SITE CONSTRUCTION PLANS FOR

PINE GLO

V1 - SDP-24-05

414 S MAIN ST ST
ROLESVILLE, NC 27571
PIN: 1758-79-7437

SITE PLAN

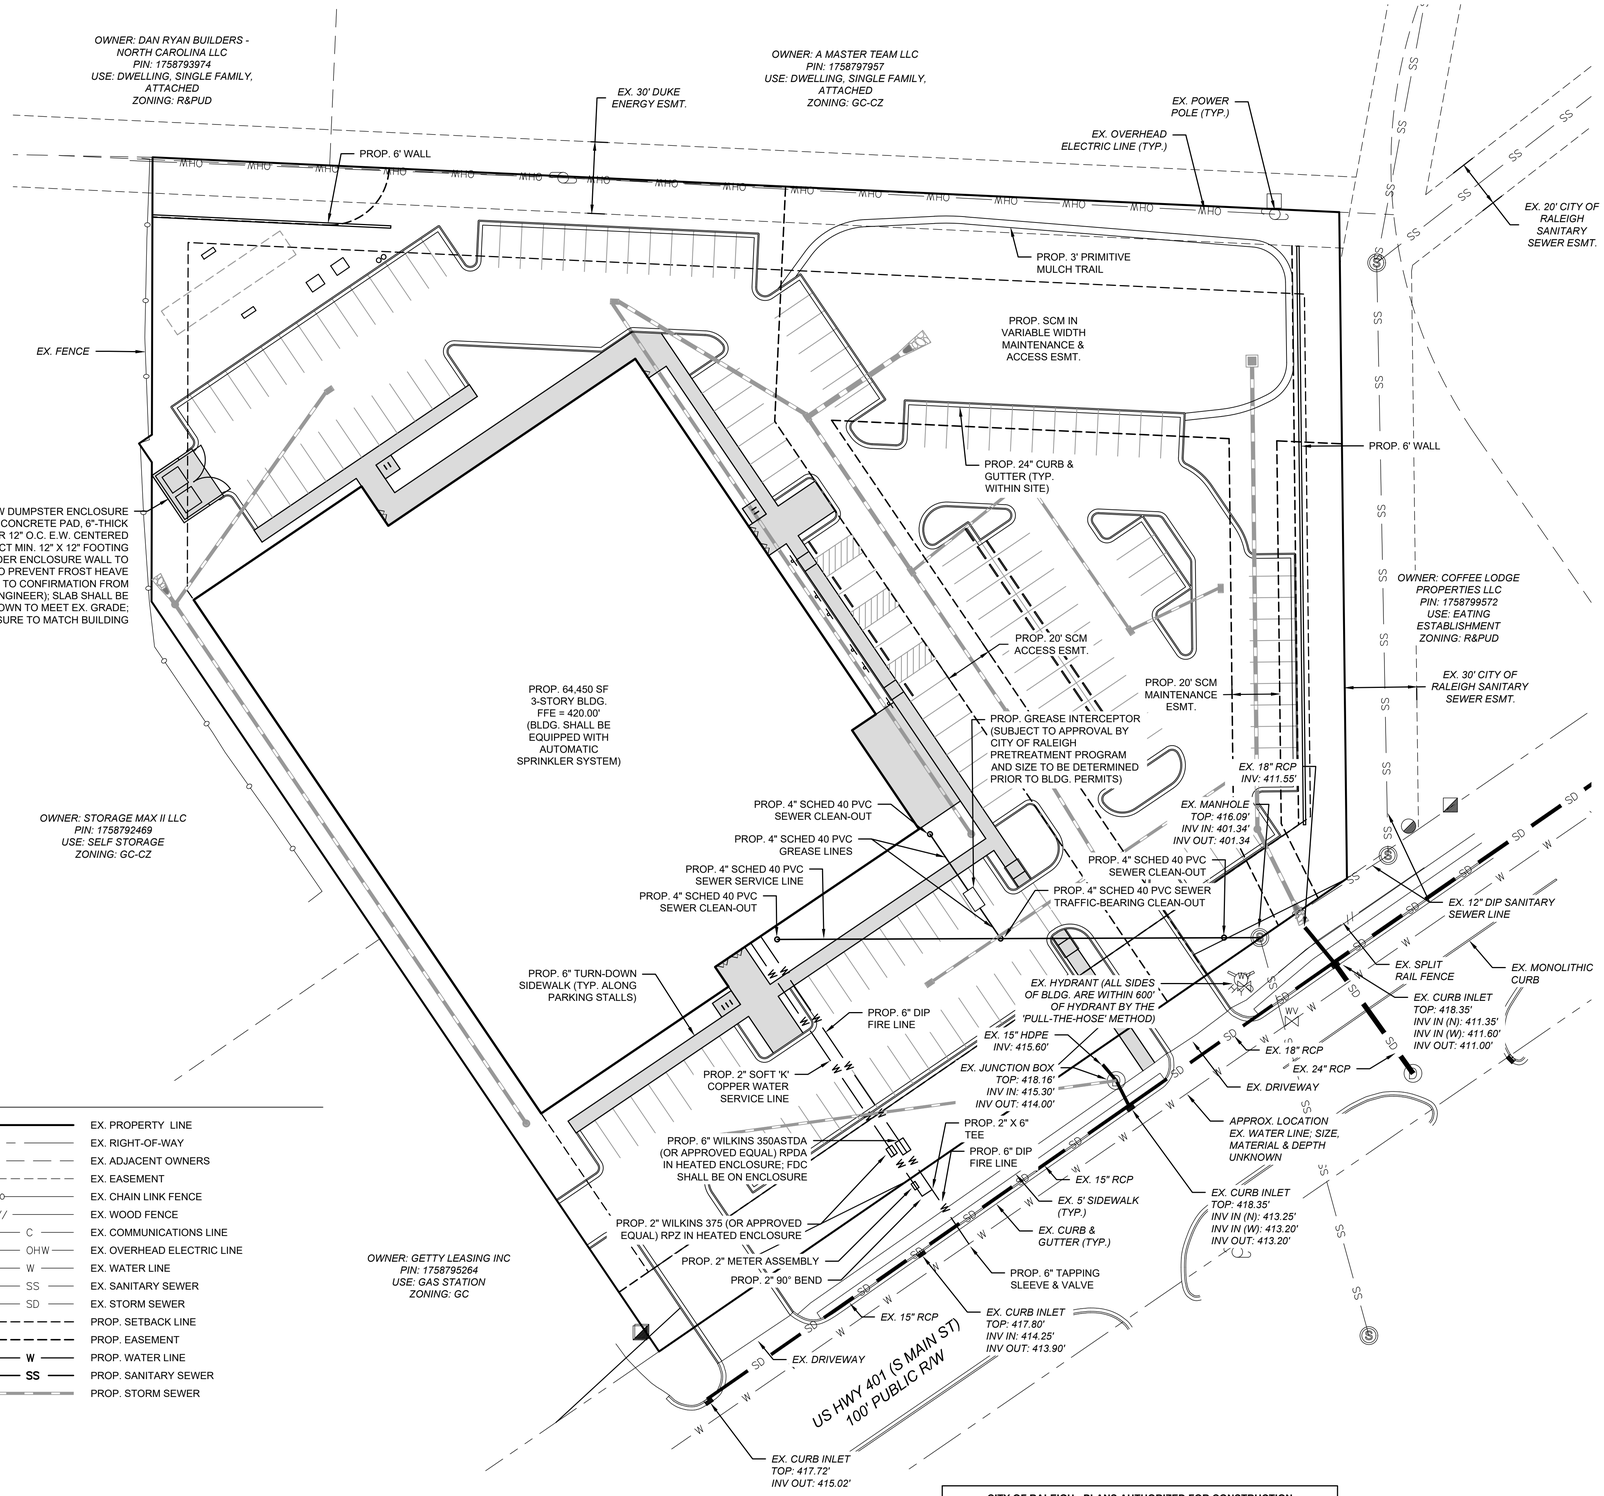
However, please refer to GC-CZ zoning comment.

Per LDO Section 6.4.3.K, an alternative parking plan must first be approved by the Board of Commissioners. This requires a parking study to be submitted which is prepared by a PE or CLU in North Carolina. Please see this section for further submittal details.

LANDSCAPING PLAN

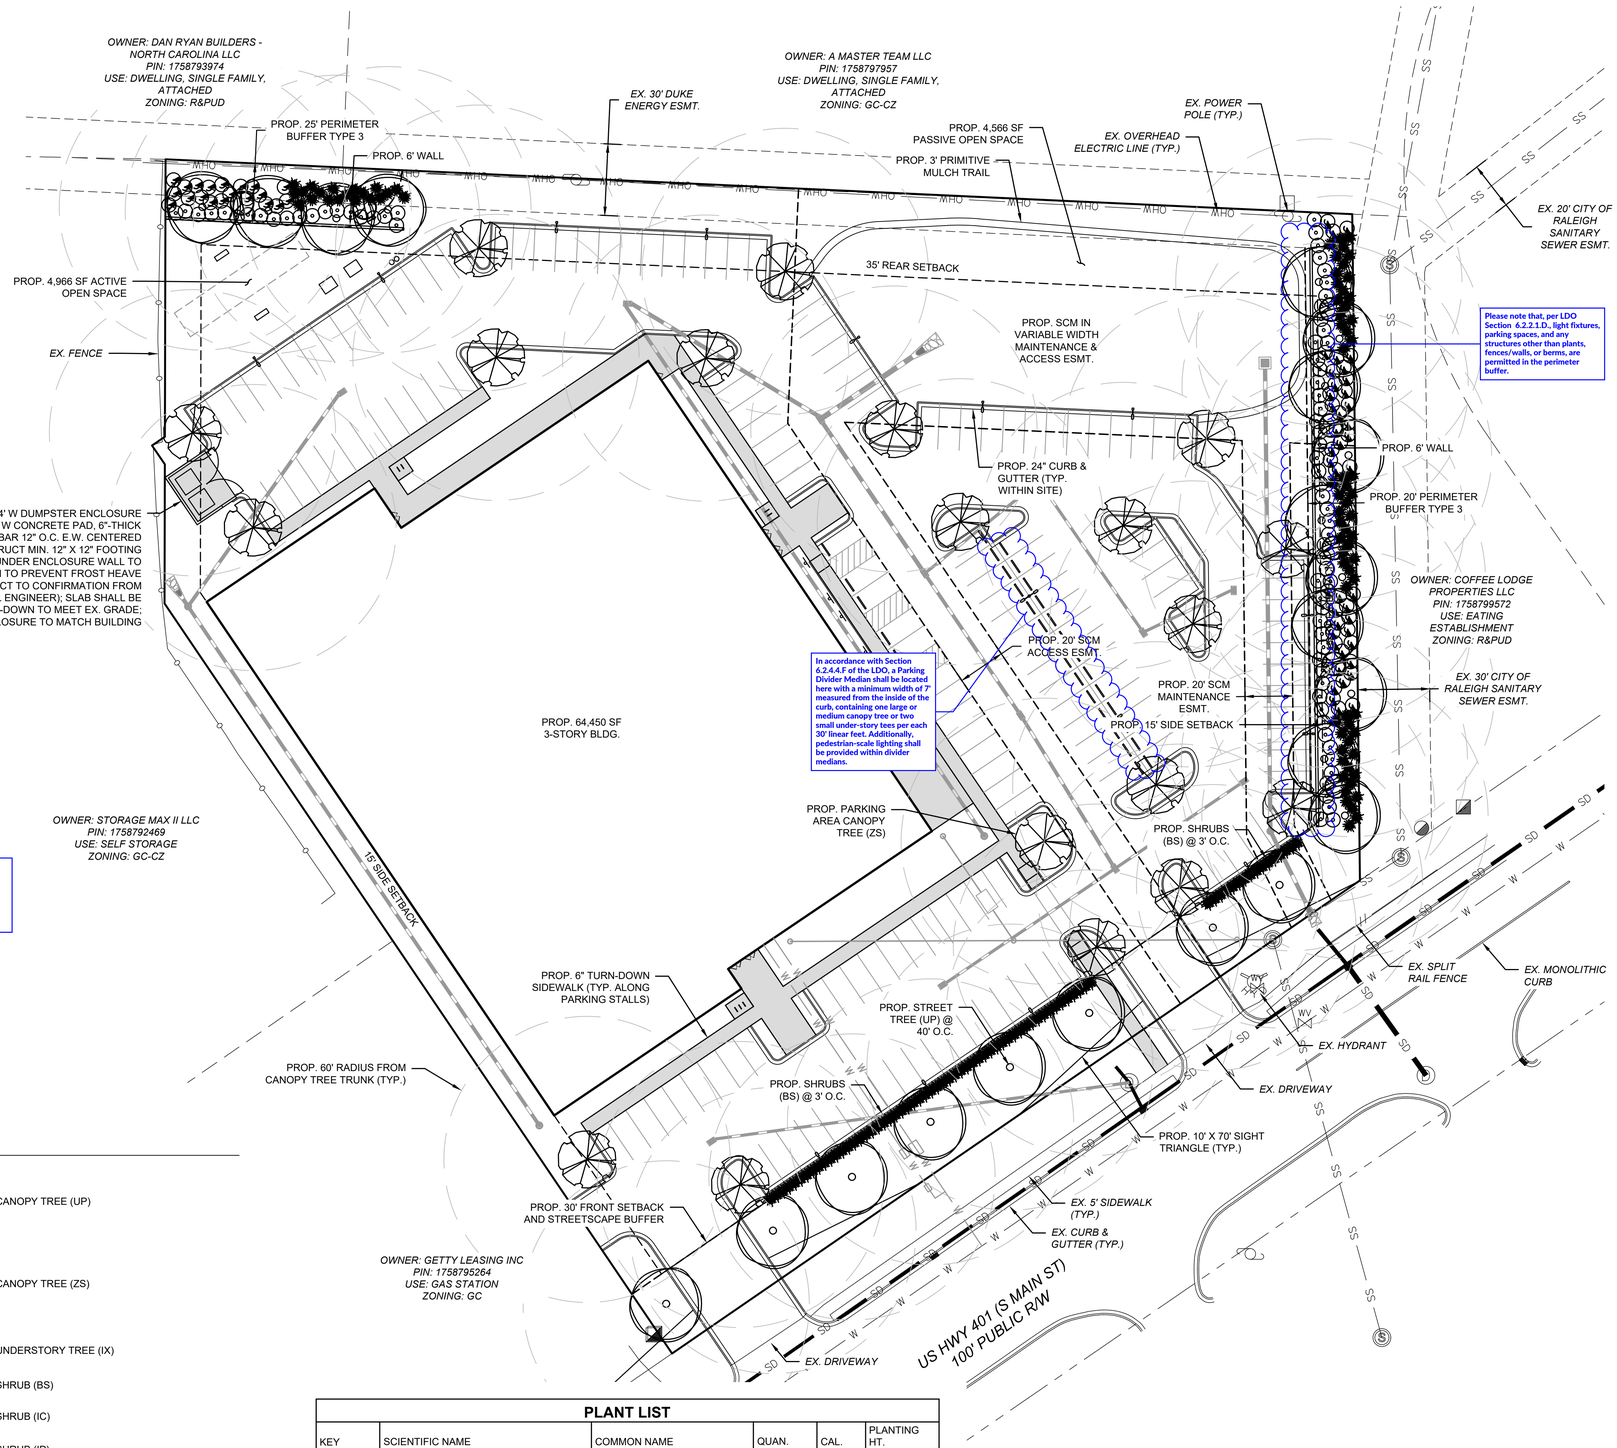
Due to R&PUD District (no longer utilized in the LDO) designation for adjoining uses, the Land Development Administrator should provide final guidance on perimeter buffer needs.

Please note that the preservation standards outlined in Section 6.2.4.5.B shall apply and a preservation plan in accordance with Section 6.2.4.5.C shall be prepared.
